UNITED STATES PATENT AND TRADEMARK OFFICE

10/725,623

Michael M. Kamrava

DETAILED ACTION

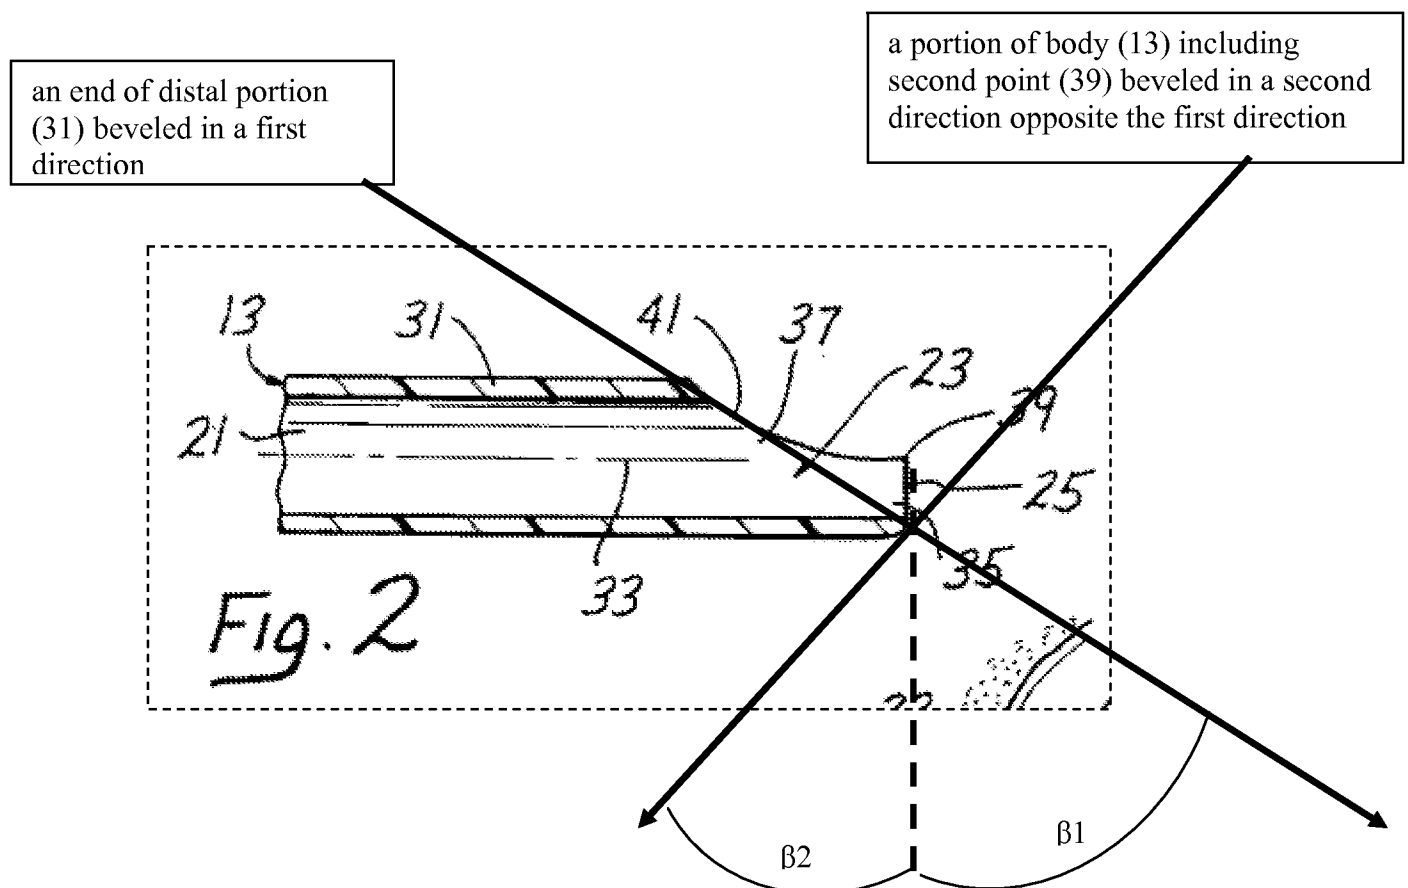
Bacich discloses a transfer catheter body (13) comprising a proximal portion (27), a distal portion (31), an elongated passage (21), the distal portion (31) having an end that is beveled in a first direction across the passage (21) from one side to another, thereby, rendering the bevel in its direction across the opening, as recited, a portion of catheter (13) including a second point beveled in a second direction opposite the first direction defining a tip, showing by $\beta 1$ & $\beta 2$ below. See illustration below.

In view of Bacich, it would have been obvious to one skilled in the art during the time of this invention to modify the Gobby's distal passage portion of the delivery section (51) such that it would have a bevel, as such would facilitate the delivery process.

With regards to claim 28 & 32, the second point on the catheter body (13) beveling on the second direction (see illustration above) yields a refined edge, thus, serving as a cutting tool.
